PARTS BULLETIN

Original Issue Date: **10/99**
 Model: **80-100DS/DSE, 150/180DS**
 Market: **Industrial**
 Subject: **Field Exciter Assembly Correction**

Figure 1. Alternator Components

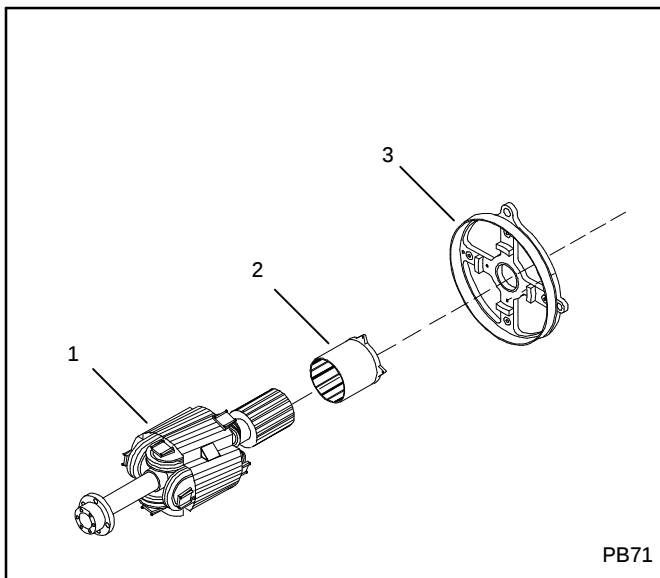
Parts Catalog MP-5681 lists the wrong field exciter assembly part number for some generator set specifications. See Figure 1 for an illustration of the field exciter assembly. Choose the correct part number from the chart. Please make a note of the correction in Parts Catalog MP-5681 6/99, 20-180DS/ESE, page 27, item 28.

Generator Set Specification	Field Exciter Part Number
80DS/DSE	
192501	276657
192502	276657
192503	276657
192504	276657
192505	276657
192506	276657
192519	276657
192520	276657
192521	276657
192522	276657
192523	276657
192524	276657
100DS/DSE	
192601	276657
192602	276657
192603	276657
192604	276657
192605	276657
192606	276657
192619	276657
192620	276657
192621	276657
192622	276657
192623	276657
192624	276657
150DS	
192803	257963
192806	257963
180DS	
192901	257963
192902	257963
192903	257963
192904	257963
192905	257963
192906	257963
